**TOWN OF OCEAN RIDGE
PLANNING & ZONING REGULAR MEETING
AGENDA**

To: Planning & Zoning Board Members
From: **Corey O’Gorman, Town Planner**
Meeting Date: September 17, 2024
Subject: 5920 N Ocean Blvd – Development Plan Review

PLAN REVIEW REPORT
5920 N Ocean Blvd
REV 5 - Summary

PLAN REVIEW REPORT
5920 N Ocean Blvd
10/16/2023 REV 1

SHEET NUMBER
A1.0

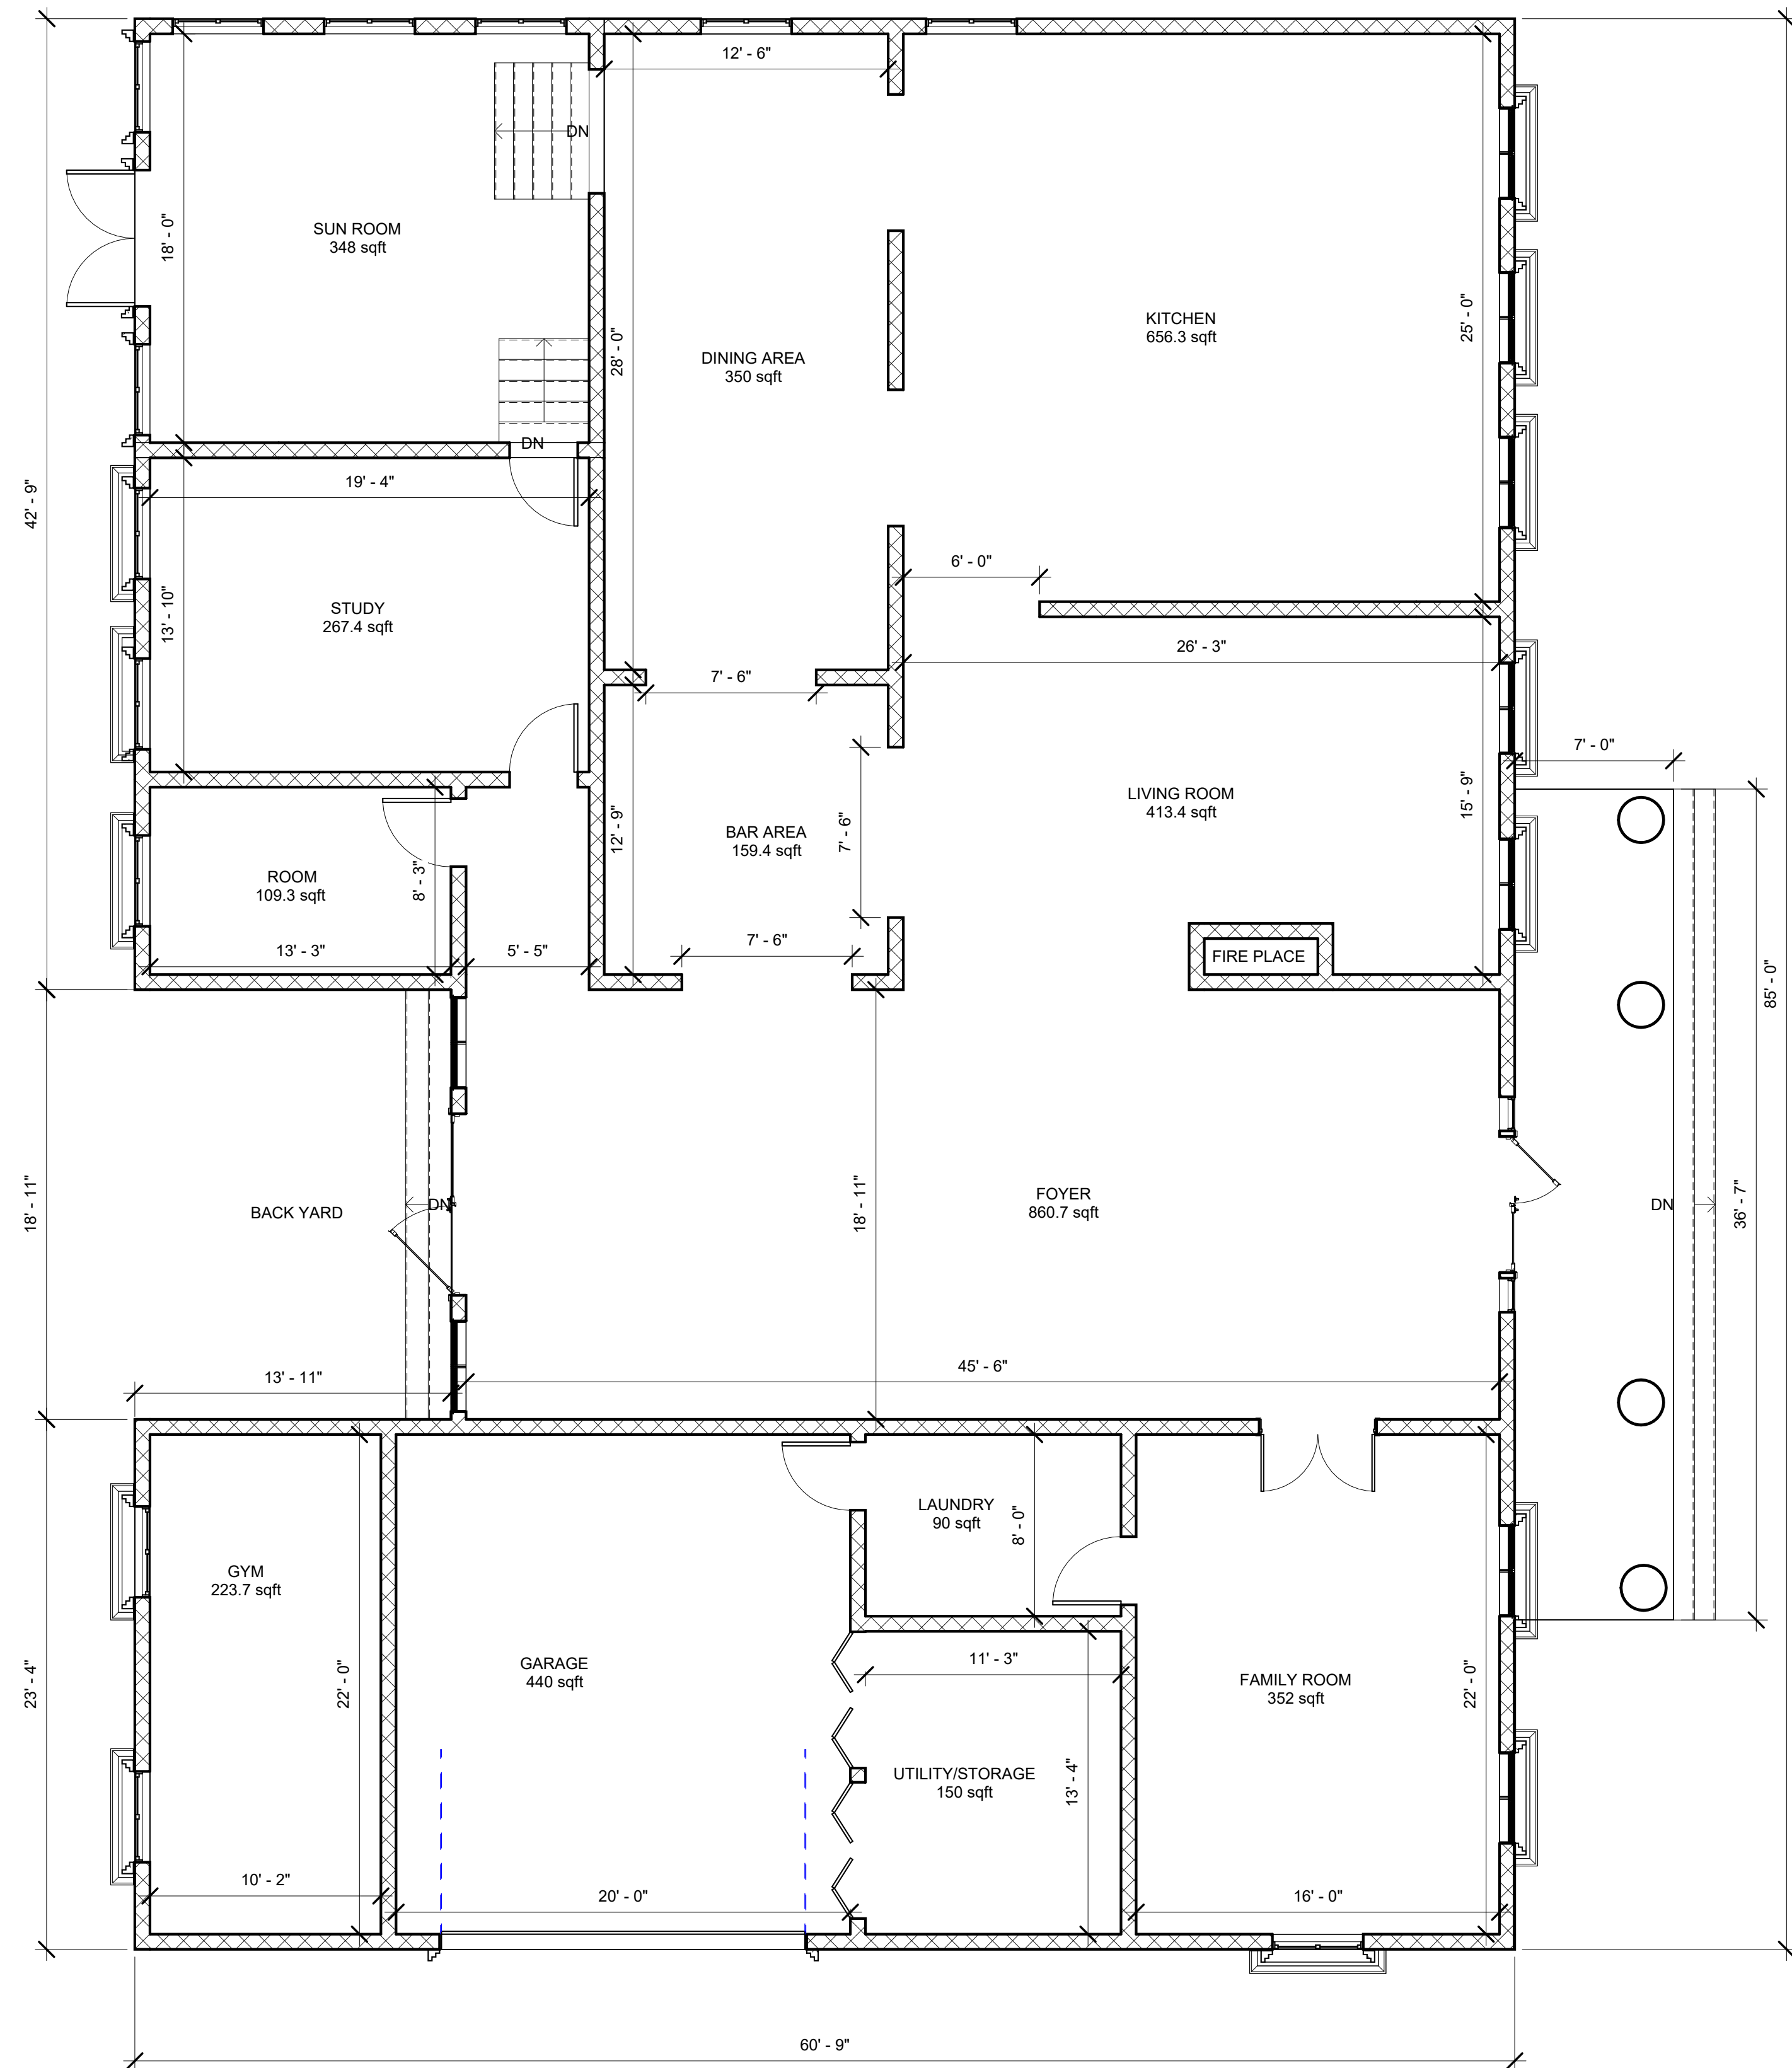
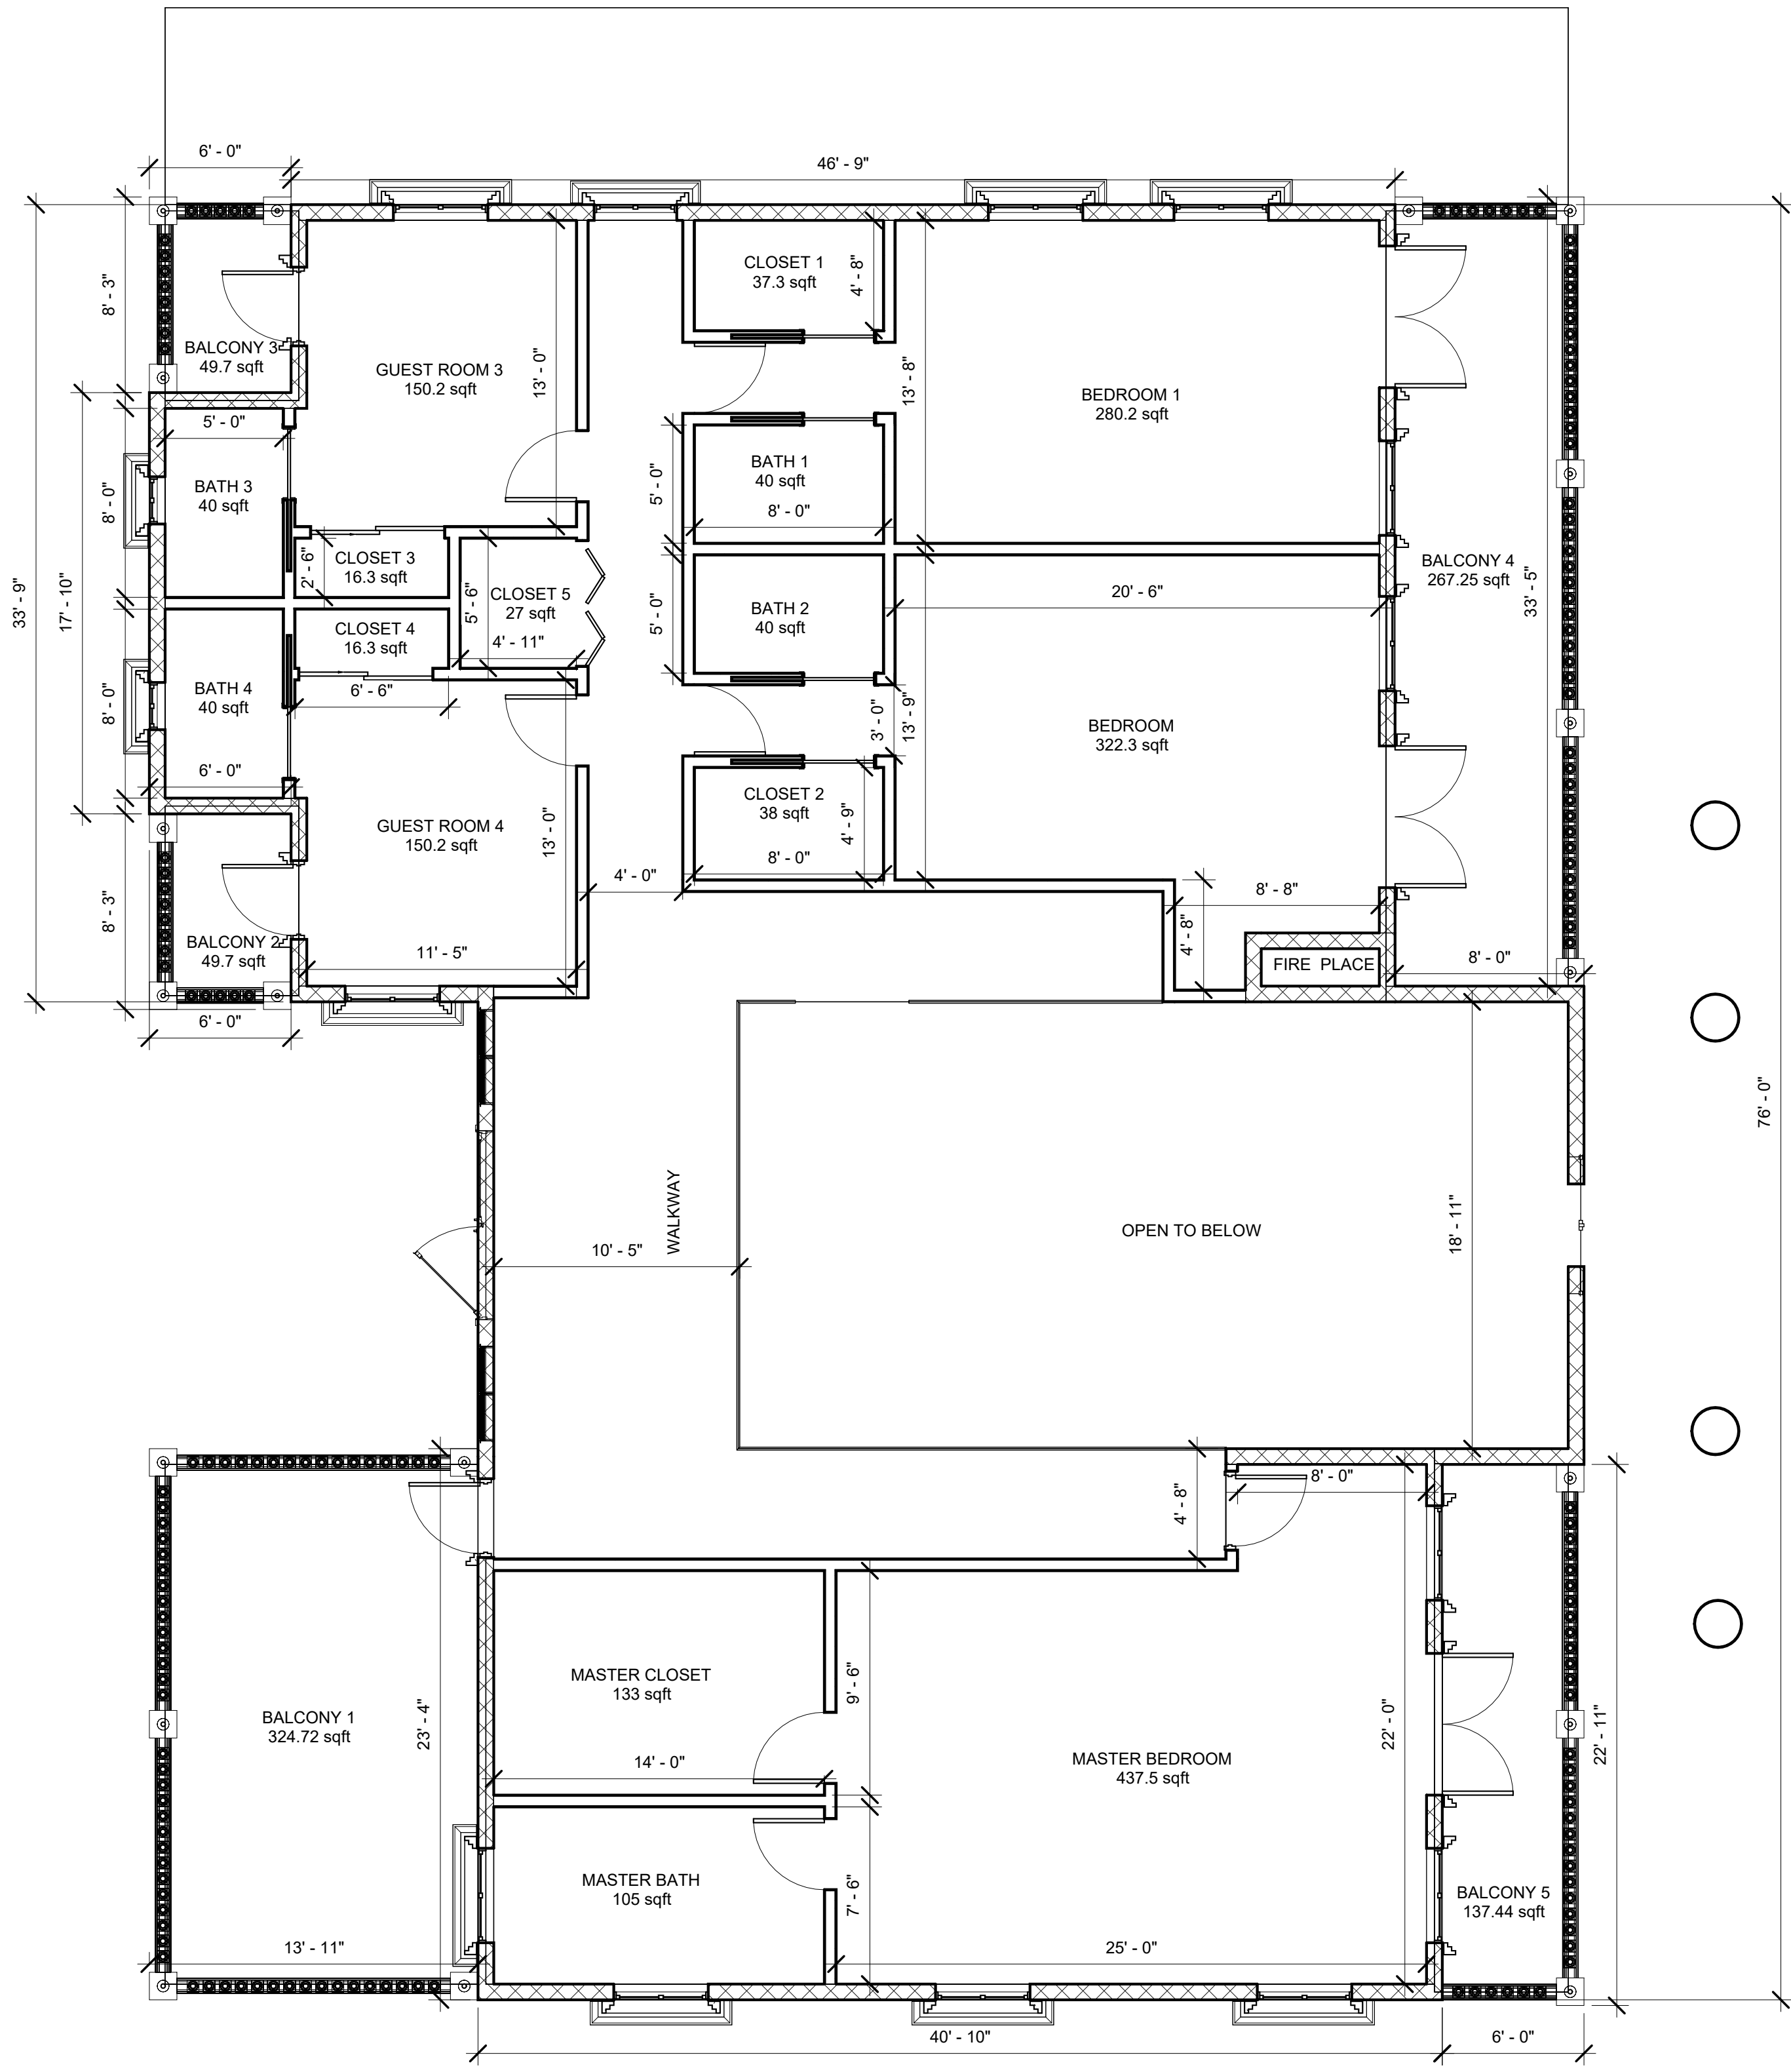
~~Comment: Although C 1.0 states that the second floor area is 72.7% of the first floor area, no calculations are provided as required in the checklist. Please revise Sheet A1.0 labeling each space and providing the calculation of 2nd floor to 1st floor to verify compliance with this section. **This comment was partially addressed by providing the labeling and dimensions, however the legend and calculations specified in the checklist were not provided with the total square footage of each space in order to confirm compliance with this section. Note that the Zoning Official has done calculations that indicate the project complies with this requirement, however the calculations are needed for confirmation. This comment is partially addressed however the square footages included on sheet A1.0 is based on interior dimensions and the Town Code defines floor area for the purposes of calculating Floor Area Ratio dimensions are taken from the exterior walls not the interior. This must be revised to be consistent with the Town Code.**~~

~~In addition, because the lot area exceeds 20,000 square feet, the FAR is limited to 0.32, and the site data on Sheet C1.0 shows a total FAR of 31.8% but no calculation is provided as required by the checklist. Please refer to the required FAR calculation on the Development Plan Review Checklist and revise Sheet A1.0 to include the required information which is as follows:~~

~~First floor plan with all rooms dimensioned and labeled (e.g., bedroom, bathroom, kitchen, etc), covered porches, patios, garage etc. Include numbering of each room that corresponds to a legend and with the total square footage of each room and space provided;~~

~~Second floor plan (if applicable) with all rooms dimensioned and labeled (e.g., bedroom, bathroom, etc), balconies etc. Include numbering of each room that corresponds to a legend and with the total square footage of each room and space provided;~~

~~Provide FAR table with all applicable rooms and spaces listed for a determination of total FAR and the percentage of 2nd floor space to 1st floor space.~~

~~Please note that as described above, the floor area is calculated using the exterior of the wall not the interior as shown on the plans.~~

REV-4: This comment is addressed.

REV-4: This comment is addressed.
